# Recall Bulletin

## PRODUCT SAFETY RECALL

**SUBJECT:** Safety Belt Lap Anchor Tensioner Cable

**MODELS:** 2011-2012 Chevrolet Malibu

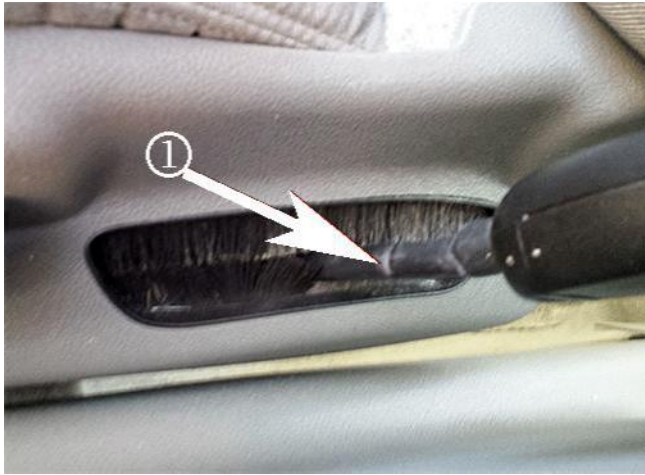
2. Inspect the safety belt shrink sleeve for any cuts or cracks. Bend the seat belt cable toward the inside (1) and outside (2) of the vehicle and carefully inspect for any cuts or cracks in the shrink sleeve.

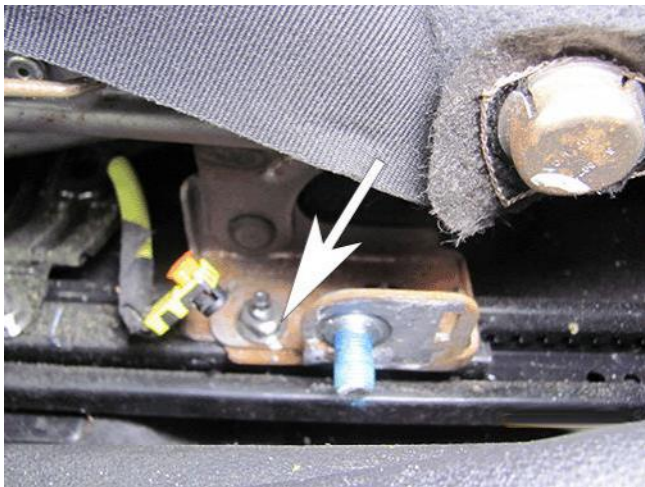
3. If a sleeve is cut or cracked on the cable (1) or where the cable meets the buckle (2), replace the front seat belt anchor plate tensioner in step #10.
4. Remove the front seat belt anchor plate tensioner. Refer to *Front Seat Belt Anchor Plate Tensioner Replacement* in SI. If the shrink sleeve does not show any damage, it is not necessary to disconnect the anchor plate from the belt.

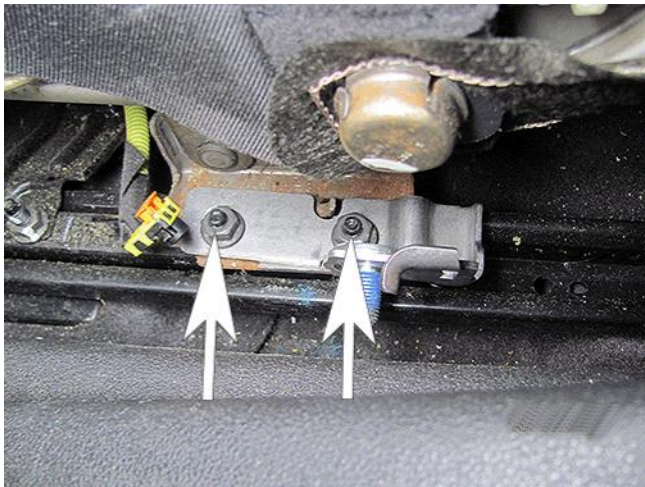
5. Locate the seat belt tensioner mounting bracket on the seat frame.
6. Remove the two attachment nuts and discard the nuts, new nuts are included with the kit.
